July 14, 1998

Re: Swale Maintenance Guidelines
ARH #74-11016

TYPICAL SECTION

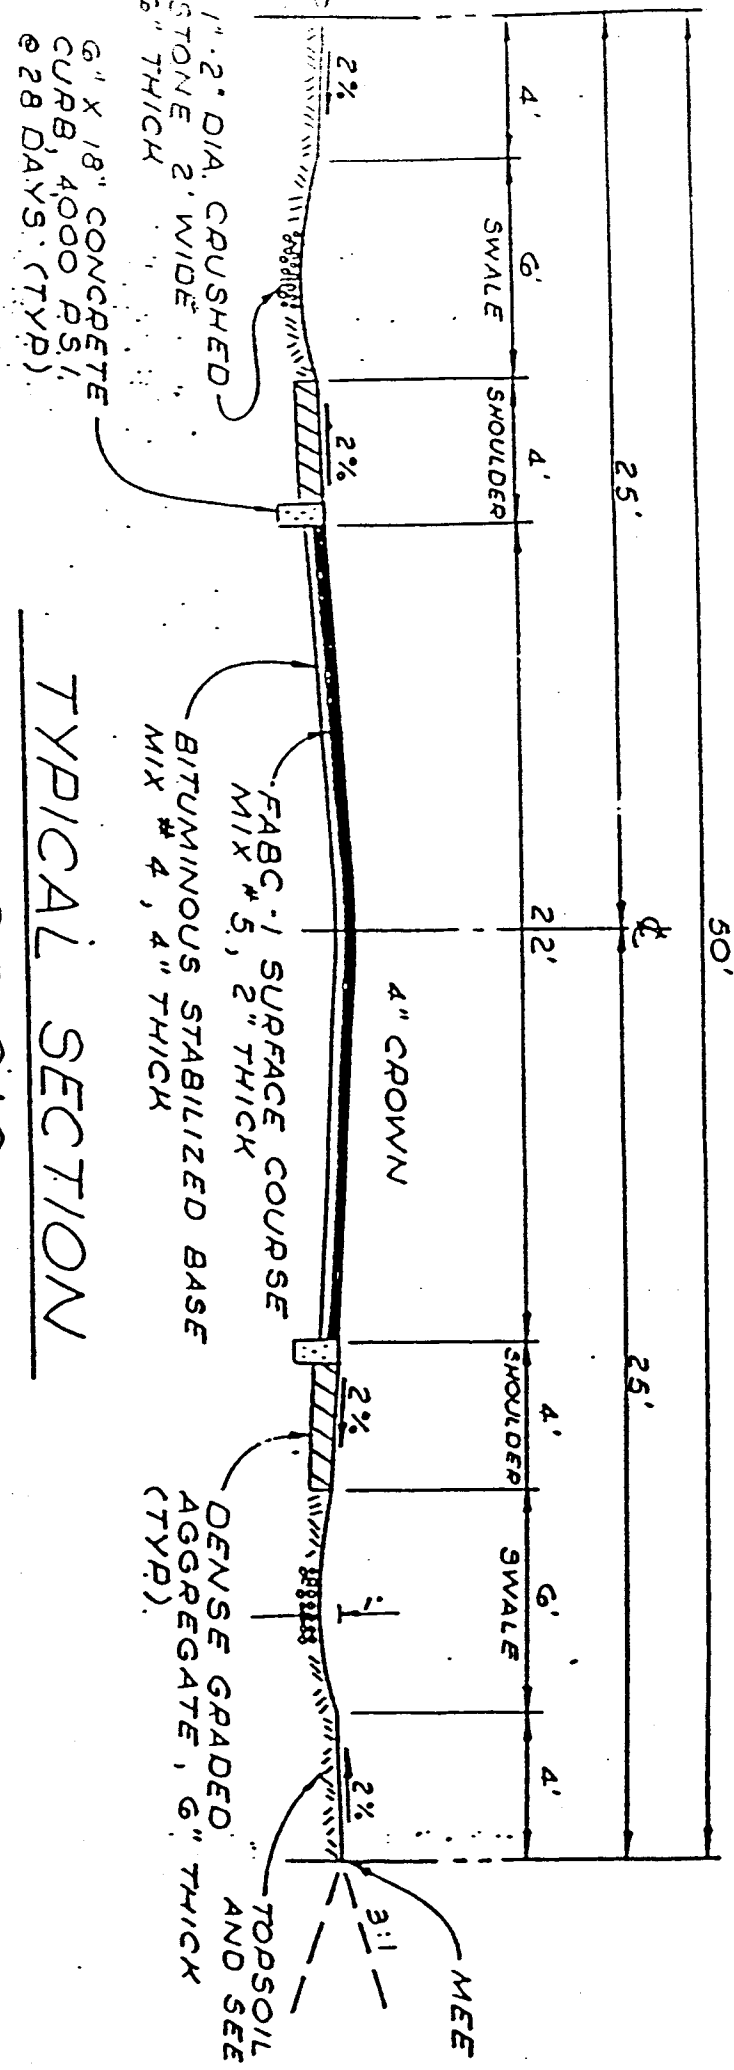
1. **Side Wall Slopes:** The purpose of designing the swales with side slopes of 45° or less was to allow easier maintenance. Unfortunately, a 45° slope or 1 to 1 slope is not easily mowed. The problem with the original plans was that a detail was used to describe the swale. The roads in the development pass through land that is not uniform, making the side slopes of the swale non-uniform.

Side slopes greater than 45° become much more difficult to maintain. We would not recommend establishing any slopes greater than 45° or 1 to 1.

6. **Maintenance of Stone:** The plans for the development call for a 6" thick stone layer. The stones do not have to be turned except for aesthetic purposes.
